**Submission of representations and formal objection to planning application
ref: 2021/5652/P**
at workshop rear of 38-52 Fortess road, Fortess grove, London NW5 2HB

- *Variation of condition 5 of planning permission ref: 2017/4731/P dated 31/10/2017 for 'Installation of replacement roof to workshop building, alterations to entrance and replacement fenestration' seeks to partially obscure glaze the rooflights on the bottom row with the rest being clear glazed at roof level*
-

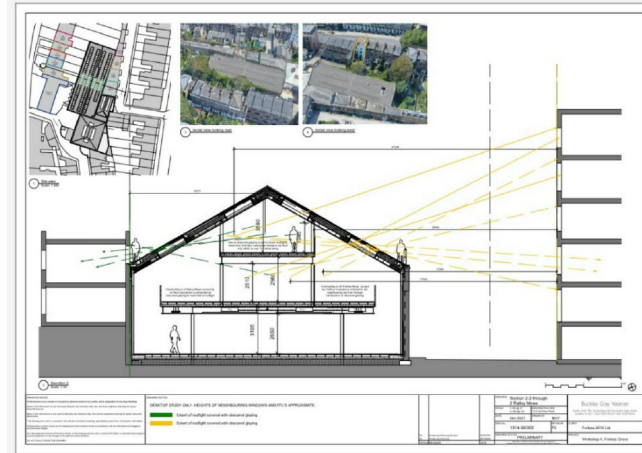
ROOF TERRACE: (my only amenity space). The application and drawing 1014-SK302 fails to provide information or account for overlooking and loss of privacy to my roof terrace from the first-floor mezzanine and staircase. To remove overlooking and loss of privacy the whole lower roof window row must be obscure glazed. Half obscured glazing will not provide adequate privacy.

The same applies to No 3 Railey mews roof terrace.

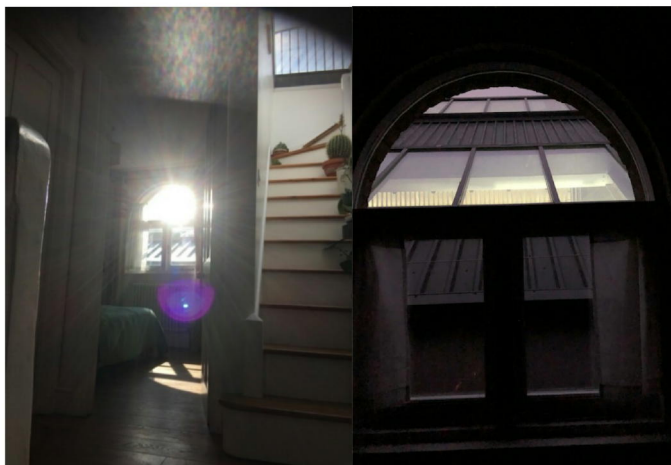
Light reflection and light pollution from both rows of roof windows will materially affect my wellbeing. Reason: the close proximity and light intensity. Once the temporary site lights are replaced with full office lighting the result to my two-bedroom windows will be overwhelming; full obscured glazing would mitigate the intensity.
